# TOWN OF GLASTONBURY

GL-2023-12

## FIRE HOUSE IMPROVEMENTS

ADDENDUM NO. 4

DWG. NO.  
**E1**

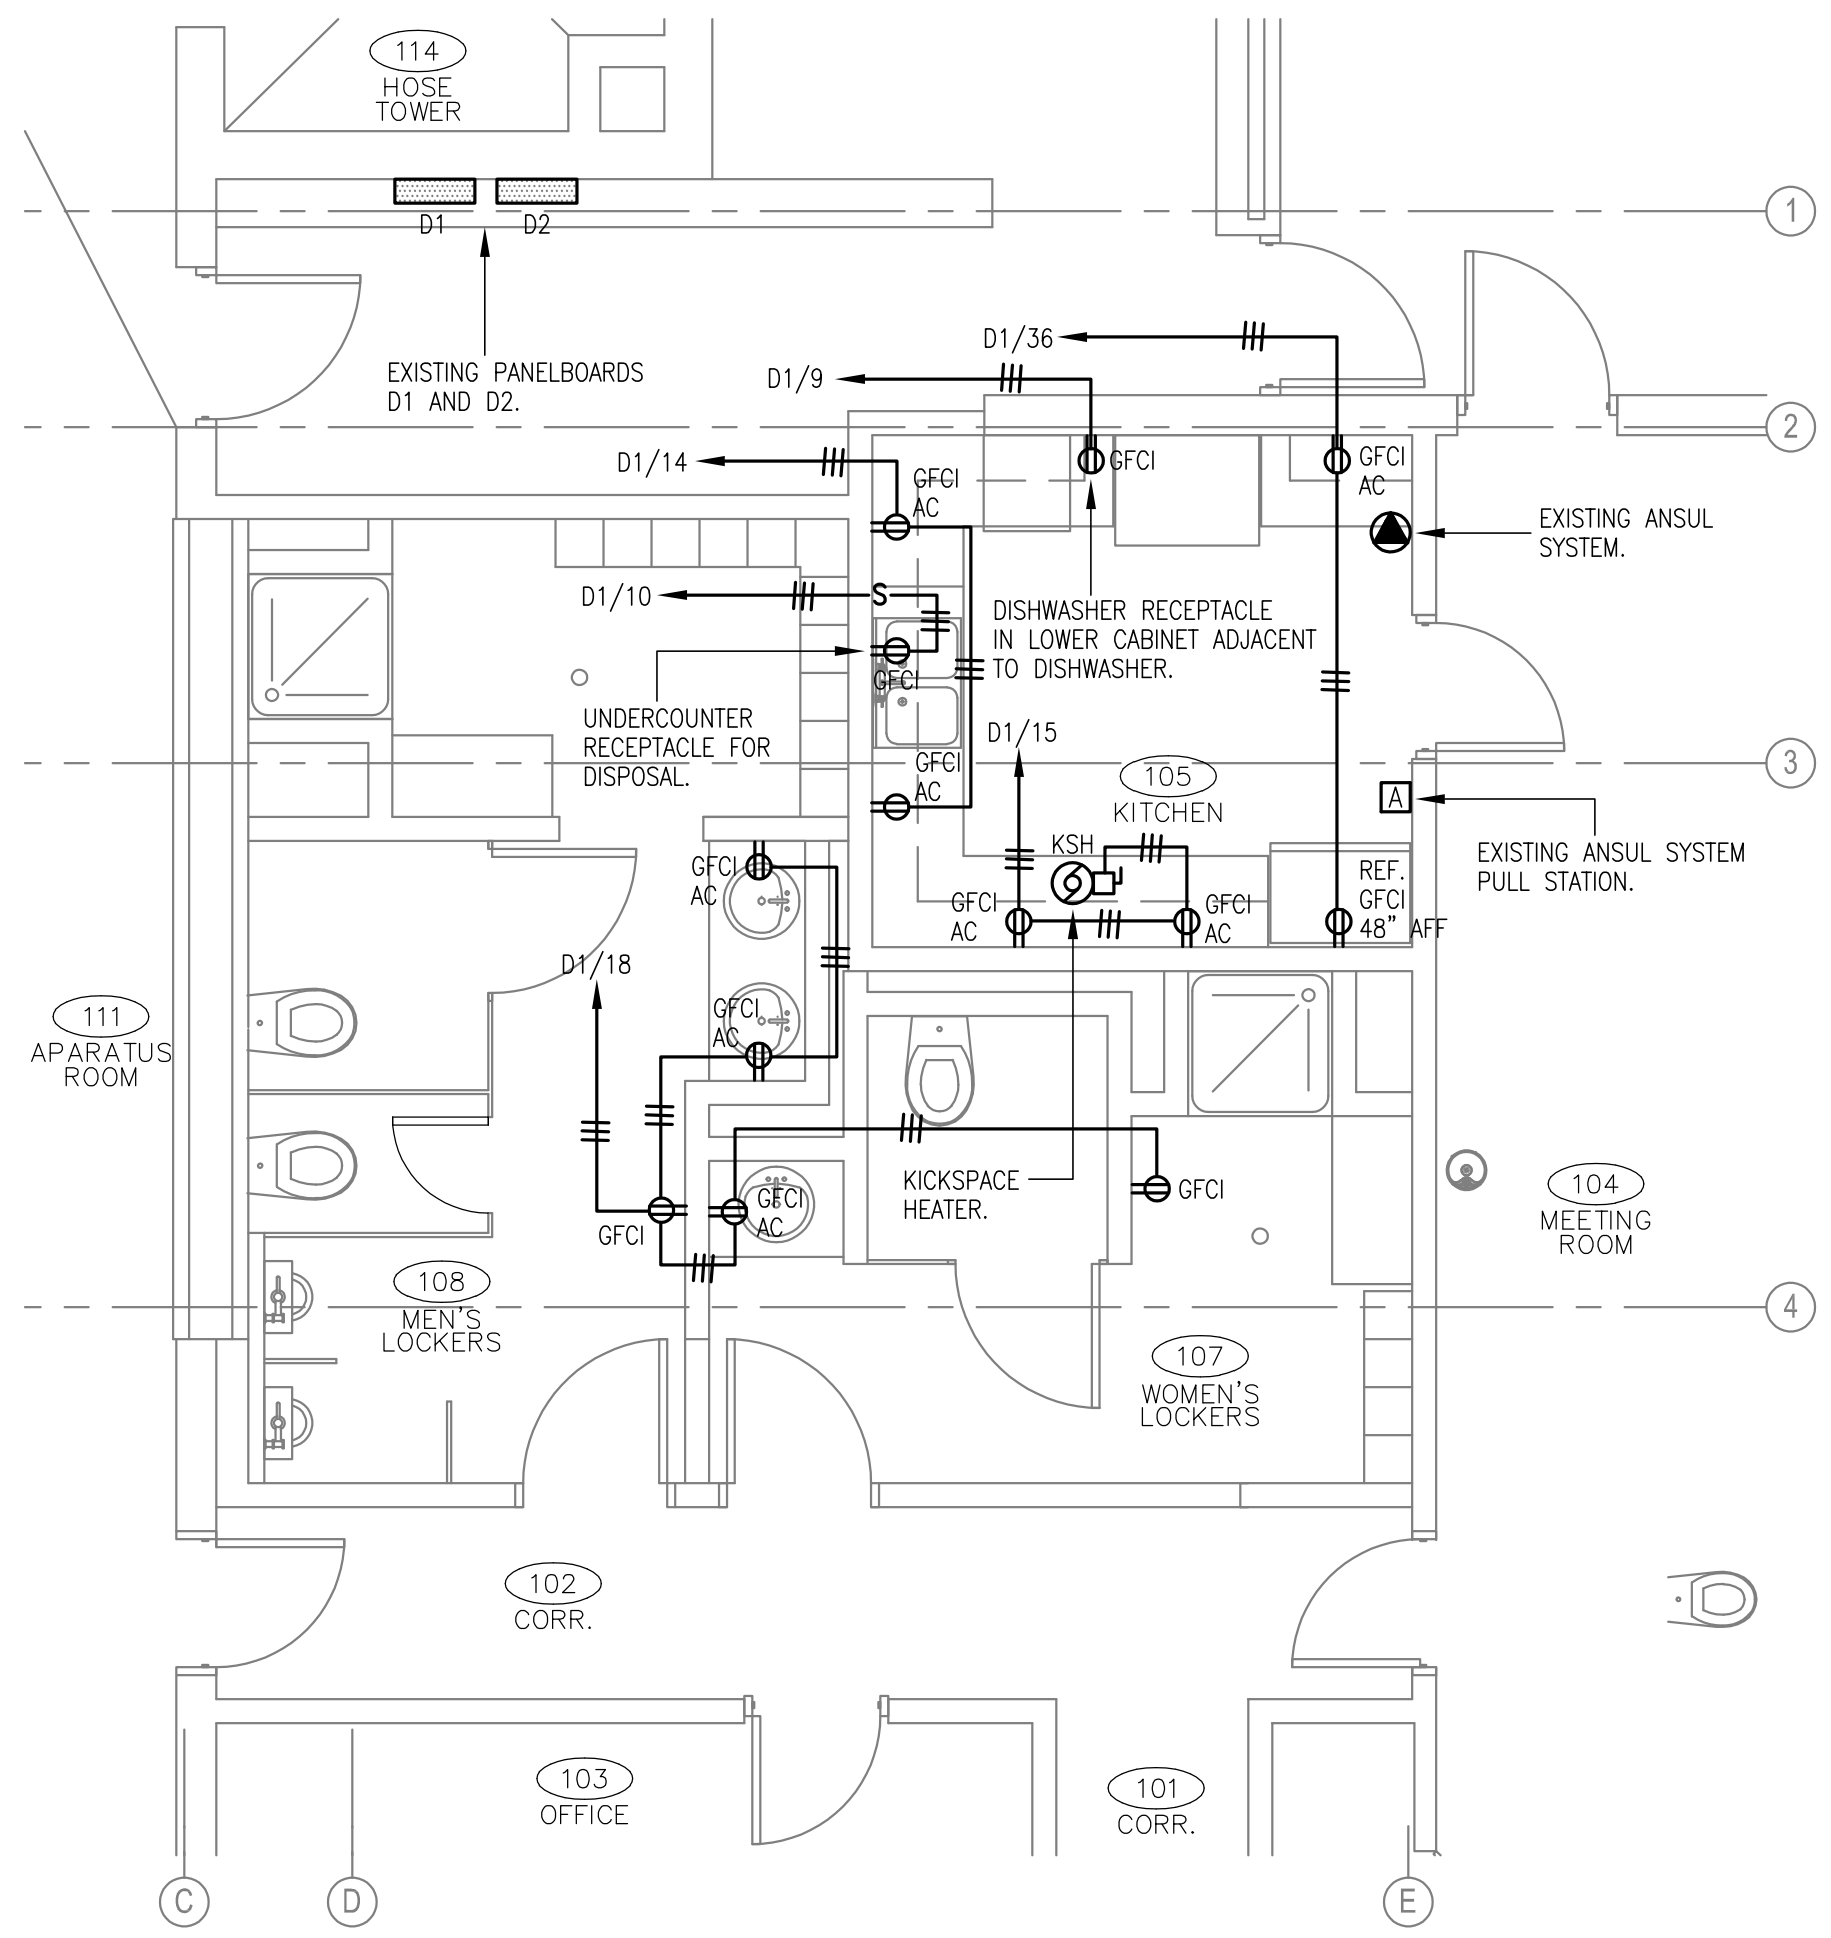
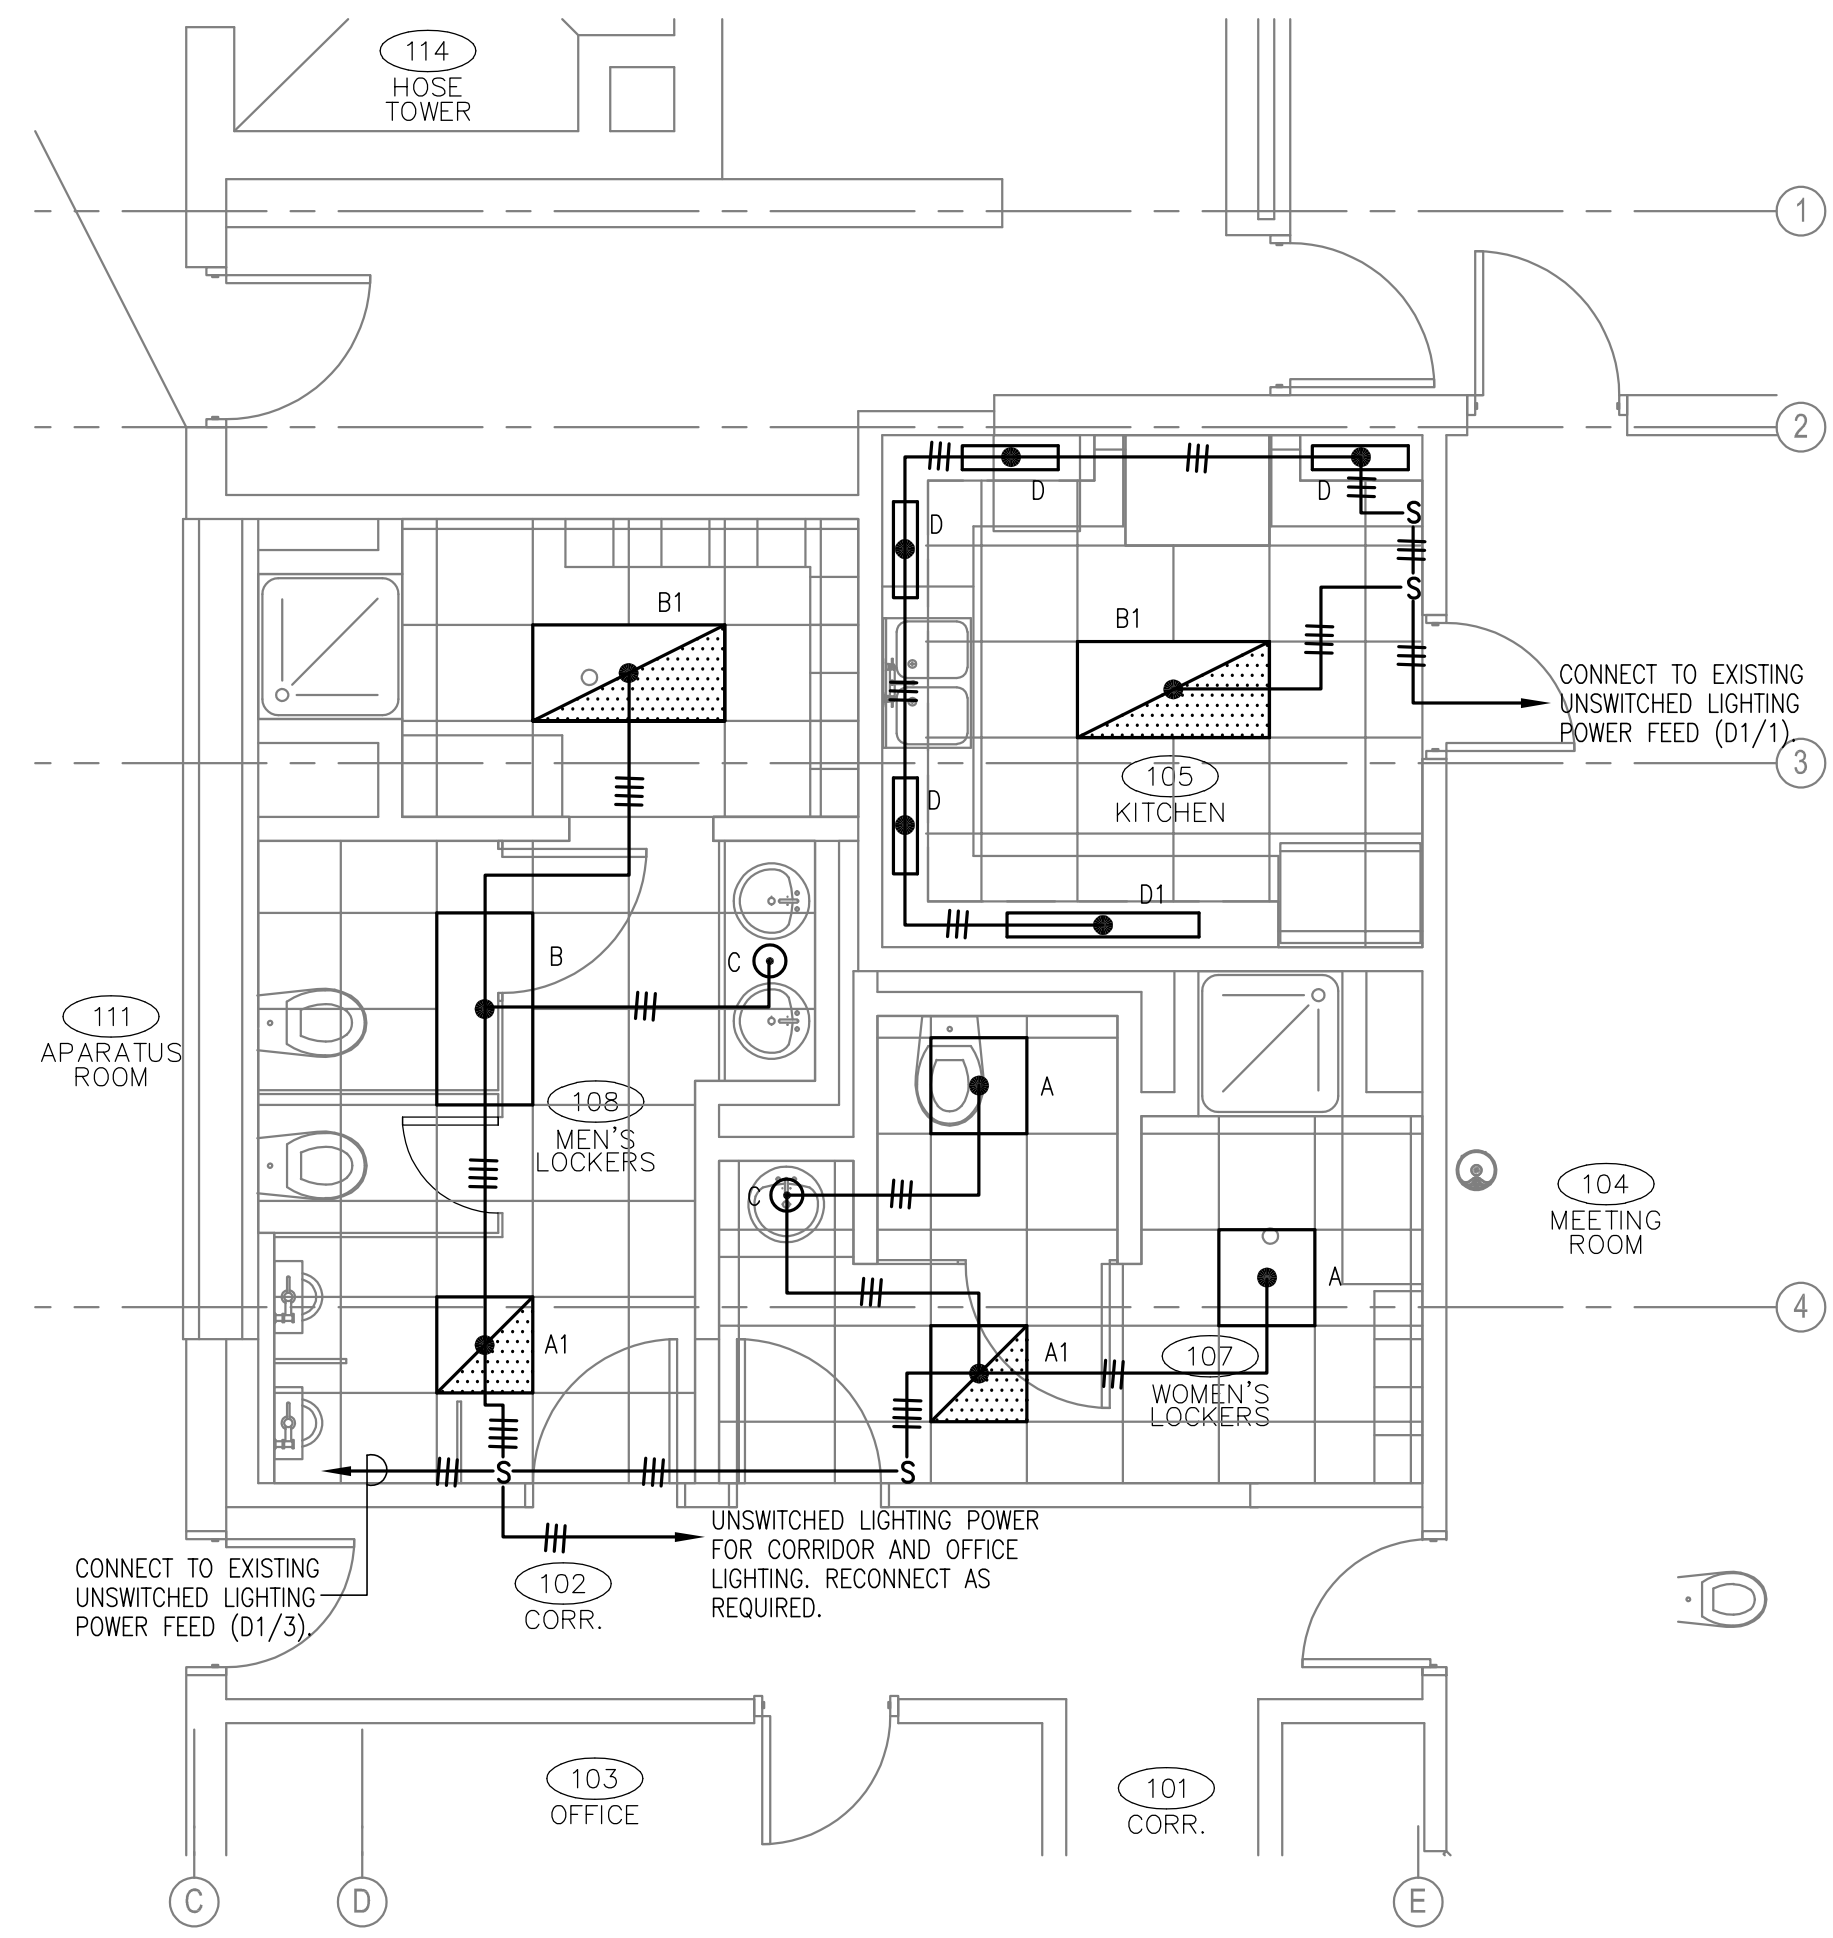
**Question 7:** *Please clearly define the extent of the electrical work the contractor is responsible for.*

**Question 23:** *Can you provide a power plan for this project or is the electrician to engineer the build?*

**Question 24:** *Can you provide detailed photos of the existing electrical distribution system (IE electrical panels, metering equipment, MDP)*

**Question 39:** *How many lights are being removed during demo?*

**Question 42:** *In reference to addendum 3, Question 10 – Are the occupancy sensors to be wall mounted type or pad mounted in the ceiling?*

**Question 46:** *Three “surface mounted heating units” are indicated on the drawings. Are these hydronic or electric? If electric, are they owner supplied/EC to install, or EC to supply and install? Please provide part number (or basis of design), and circuiting requirements for each heater.*

**Answer:** See Drawing E1

**Answer:** See Drawing E1

**Answer:** See Drawing E1, verify in field

**Answer:** See Drawing E1

**Answer:** See Drawing E1

**Answer:** See Drawings E1, M1
